24th July 2023

Ref New Garden of Remembrance, Mavesyn Ridware (OFS: 2023-081254).

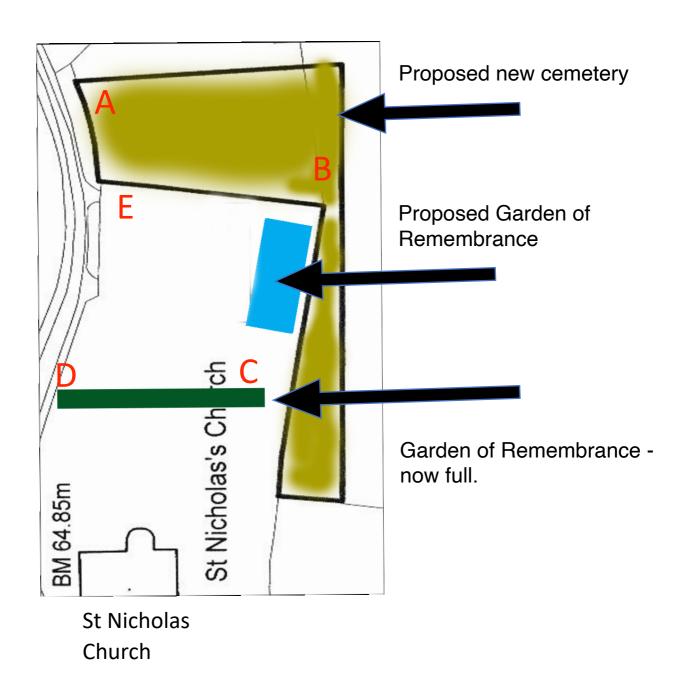
- 3. The markers seem to be rather tightly packed, with only 6 cm between each marker. The need for markers to be 45 cm x 45 cm was questioned; it should be possible to fit two inscriptions onto a stone 30 cm x 45 cm.

6. The DAC Archaeology Adviser recommended that the parish should also provide a plan showing the location and extent of proposed Garden of Remembrance within the churchyard. It is noted, however, that it is located within a 20th-century extension to the historic churchyard.

the point that the DAC are making here concerns spacing the markers, and are happy to submit a proposal that envisages a much wider space. Please view the attached updated graveyard map, envisaged with smaller cremated remains markers and a wider separation between each marker.

The includes below a map of the churchyard, showing both the Old Garden of Remembrance, the site of the proposed New Garden of

Remembrance. We also include pictures which demonstrate how close to the churchyard, will be any memorial garden located in a future adjacent secular memorial garden.
